APPENDIX J

City of Madison Coordination

East Washington and Stoughton Road Ratings and Preferences

Subject: Staff Comments on North Stoughton Rd Design Alternatives, version 3. With Transportation Commission Comments

Figure 3 Commercial Avenue Alternatives

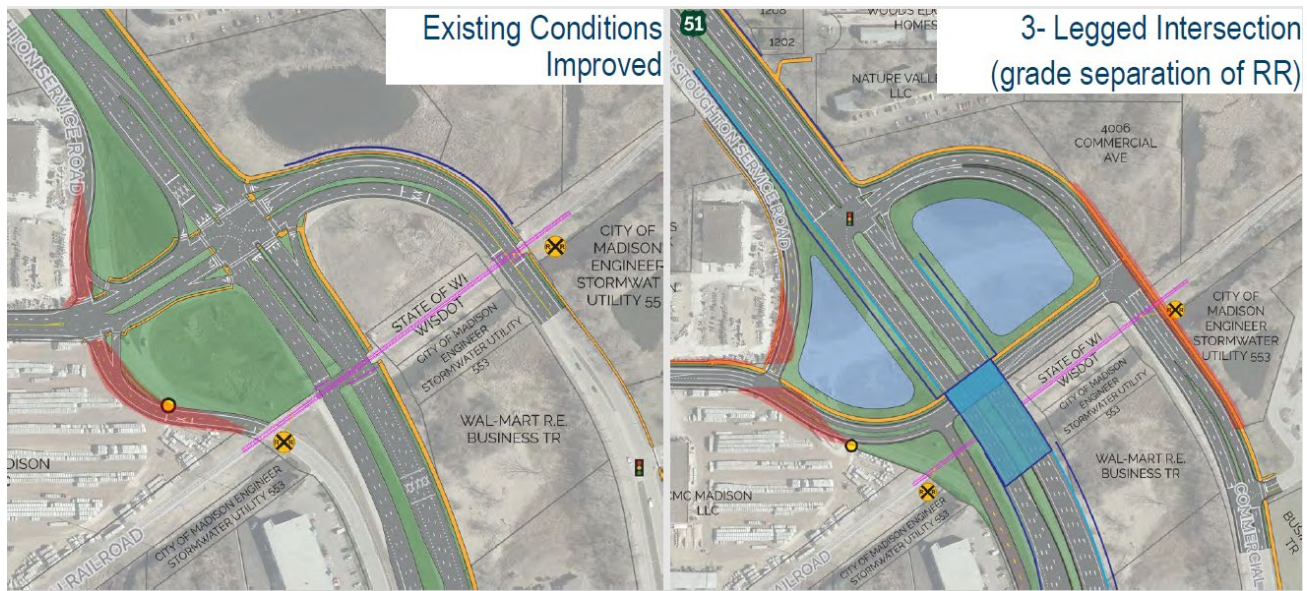
Staff support the partial jug handle over the existing conditions alternative. It provides a local road connection across Stoughton Road with an “All Ages and Abilities” crossing for bicycles and pedestrians. The jug handle restores the grade separated crossing of the railroad that existed prior to 1990, aiding in the restoration of passenger rail. If restored, the grade separation would eliminate crossing exposure and substantially decrease crossing risk. Discussions with Amtrak representatives also indicate that they strongly prefer an alternative that includes a grade separation of the railroad.

Figure 4 Highway 30 Alternatives and Pedestrian Routing

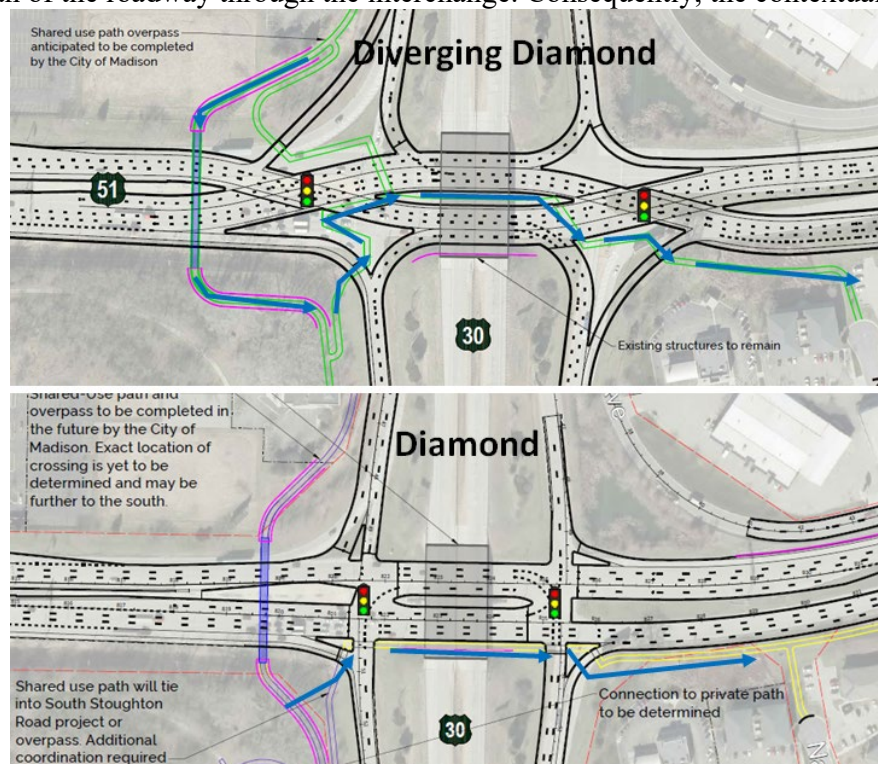
Madison prefers the conventional diamond interchange over the diverging diamond interchange. While north-south pedestrian/bicycle volumes are not anticipated to be large, the crossings of a diverging diamond are not “All Ages and Abilities”. The diverging diamond requires pedestrians and cyclist to cross and walk along the median of the roadway through the interchange. Consequently, the contextual clues used by the visually impaired do not exist. Also crossing to and walking/biking in the unprotected median would be challenging for younger users. The conventional diamond does not decrease operations significantly and we believe provides a more intuitive and safer facility for vulnerable users.
